FINAL PLAT
PINE MEADOW SECOND ADDITION
AN ADDITION TO WICHITA, SEDGWICK COUNTY, KANSAS

RE: SUB 2001-98 -- One-Step Final of Pine Meadow Second Addition

RE: SUB 2001-98 -- One-Step Final of Pine Meadow Second Addition

CASE NUMBER: SUB 2001-98 -- PINE MEADOW SECOND ADDITION

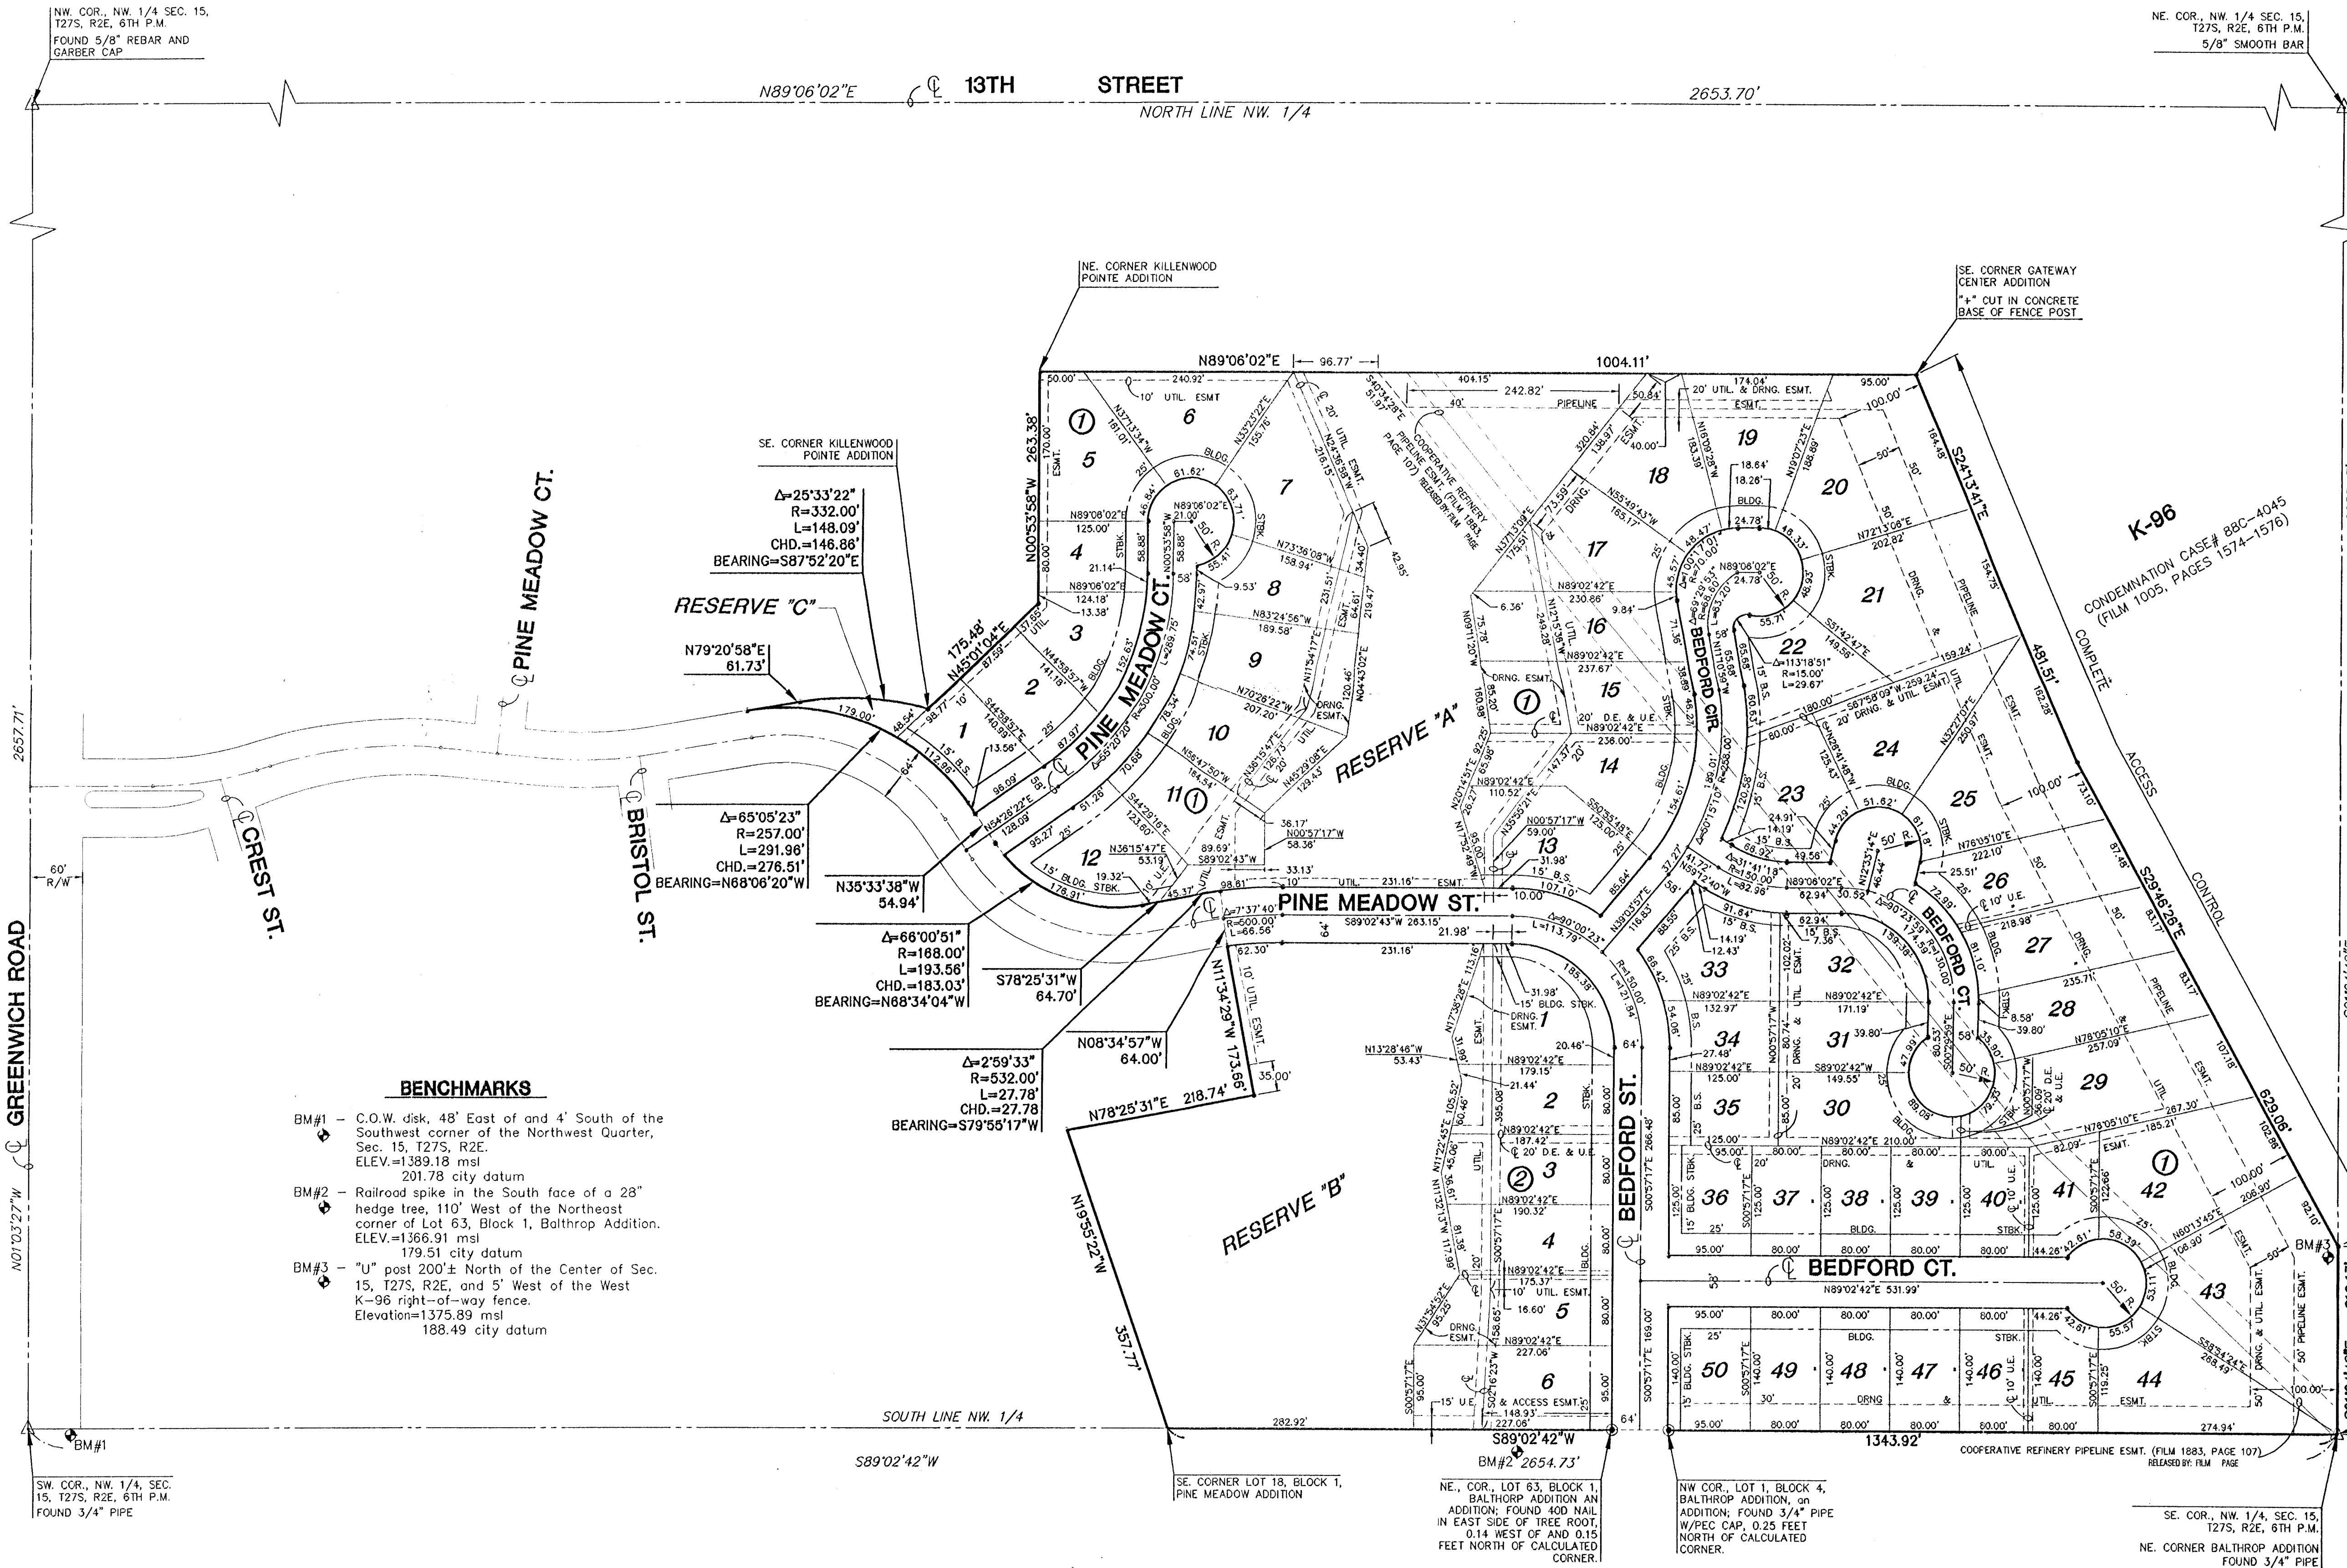
- A. The applicant shall guarantee the extension of sanitary sewer. This guarantee shall be with the City for service through the Four Mile Creek sanitary sewer system.

- B. The applicant shall guarantee the extension of City water to serve the lots being platted.
- C. If improvements are guaranteed by petition, a notarized certificate listing the petitions shall be submitted to the Planning department for recording.

- D. **City Engineering** needs to comment on the status of the applicant's drainage plan. *The drainage plan is approved.*
- E. The Applicant shall guarantee the paving of the proposed streets. The guarantee shall also provide for sidewalks on one side of Pine Meadow/Bedford.

- F. The applicant shall submit a covenant which provides for four (4) off-street parking spaces per dwelling unit on each lot which abuts a 58-foot street. The covenant shall inventory the affected lots by lot and block number and shall state that the covenant runs with the land and is binding on future owners and assigns.

- G. The applicant shall submit a copy of the instrument which establishes the pipeline easements on the property, which verifies that the easements shown are sufficient and that utilities may be located adjacent to and within the easements.

- H. The applicant's agent shall determine any setback requirements for the pipelines by researching the text of the pipeline agreements. If a setback from the pipeline easements is provided for in the pipeline easement agreements, it shall be indicated on the face of the plat.

- I. The recording information for all pipeline easements shall be indicated on the face of the plat.
- J. The Subdivision regulations discourage the inclusion of pipeline easements within the perimeter of residential lots. It is recommended that the pipeline crossing Block 1 be included within a Reserve. In the alternative, a restrictive covenant shall be provided indicating the pipeline easement within the pertinent lots.

- M. The blocks need to be renumbered as the perimeter of the blocks should be bounded by streets.
- N. Approval of this plat will require a waiver of the lot depth to width ratio of the Subdivision Regulations for Lots 9, 13-16, Block 1. The Subdivision Regulations state that the maximum depth of all residential lots shall not exceed 2.5 times the width. *A modification has been approved.*

- O. The County Fire Department/GIS needs to comment on the plat's street names. *GIS has requested that Pine Meadow and Pine Meadow Ct be renamed Killenwood and Killenwood Ct.*

- Z. The representatives from the utility companies should be prepared to comment on the need for any additional utility easements to be platted on this property. **KGE and Southwestern Bell have requested additional easements.**
